RESPONSE TO REQUEST FOR ADDITIONAL INFORMATION

APR1400 Design Certification

Docket No. 52-046

RAI No.: 412-8525
SRP Section: 08.04 – Station Blackout
Application Section: 8.4
Date of RAI Issue: 02/22/2016

Figure 1 Simplified Electrical Connection Diagram of the AAC GTG

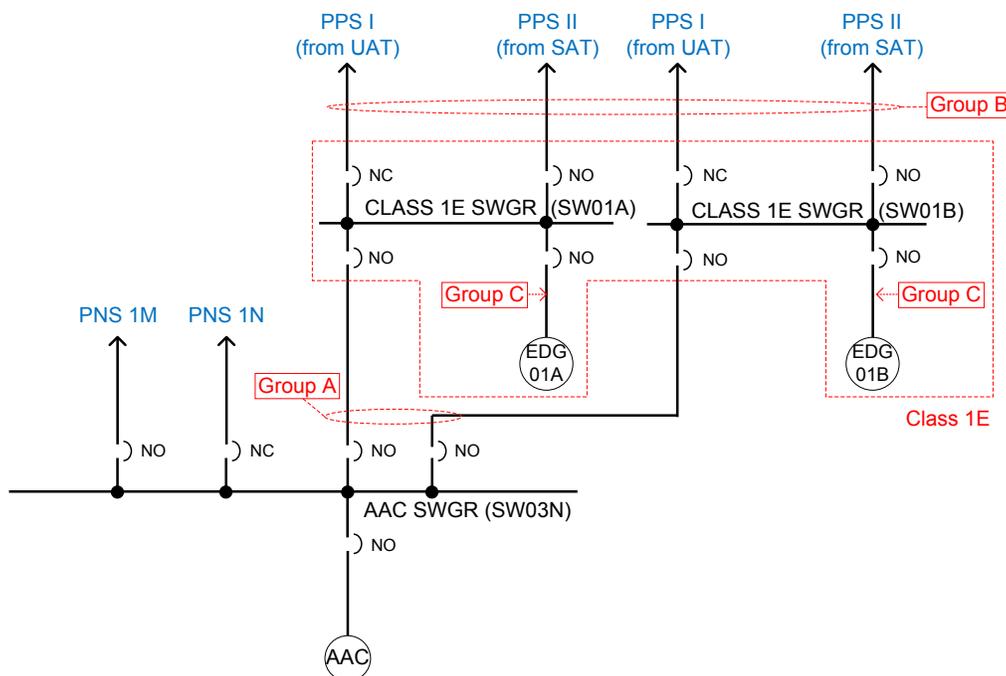
- a. Please provide a description of how the AAC power source is connected to the PPS.
- b. The applicant states: “The connections between the non-Class 1E AAC [switchgear] SWGR 3N and each Class 1E SWGR 1A and 1B are separated from the cables connecting the Class 1E SWGR 1A and 1B to the PPS as practicable such that impact on the connections of the AAC power source is minimized for events that affect the PPS.” Please provide the safety classification of cables connecting the AAC SWGR 3N to the Class 1E SWGR 1A and 1B, the Class 1E SWGR 1A and 1B to the PPS, and the Class 1E emergency diesel generators (EDGs) to the Class 1E SWGR 1A and 1B. Also, please discuss how the APR1400 design conforms to NRC RG 1.75 in regards to the separation of the cables.

- a. The alternate alternating current (AAC) gas turbine generator (GTG) is connected to the non-Class 1E 4.16 kV SWGR 3N (AAC SWGR 3N) through a normally open circuit breaker (CB). The AAC SWGR 3N is connected to each Class 1E 4.16 kV SWGR 1A and 1B through two normally open CBs in series. Since the AAC GTG is aligned to either the Class 1E switchgear 1A or 1B only in the event of a station blackout (SBO), there is no chance of connecting the AAC GTG to the preferred power supply (PPS). To illustrate the electrical connections among the AAC GTG, PNS SWGR, Class 1E SWGR, and PPS, a simplified diagram is provided, refer to Figure 1 below.
